SERVICE BULLETIN

M-1413

2015 STREET XG FUEL PUMP SAFETY RECALL 0167

Figure 1. Fuel Pump

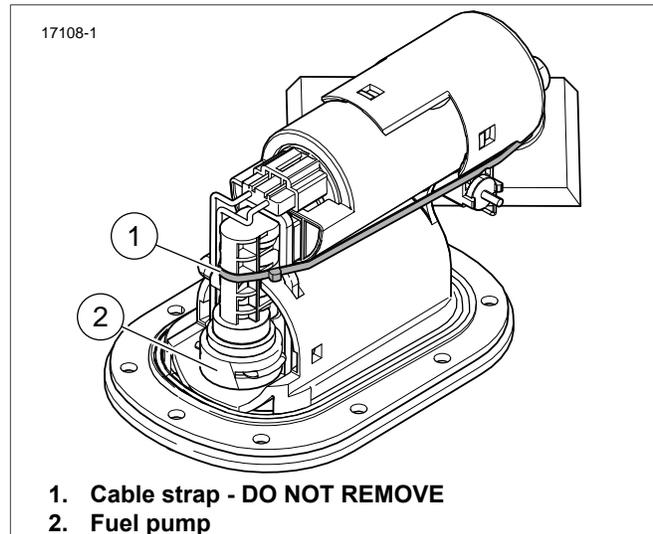
See Figure 1. Do not remove cable strap (1) from new fuel pump (2). The fuel pump is to be installed with the cable strap on the fuel pump.

2. Replace the fuel pump. See the service manual.

Figure 2. Vent Baffle

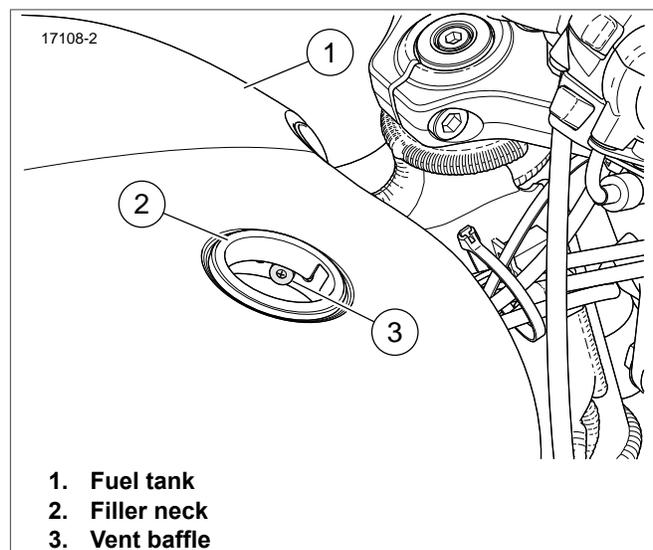
4. See Figure 2. Remove the vent baffle (3) from the filler neck (2).
5. Install the **new** vent baffle.
6. Install the fuel tank cap.
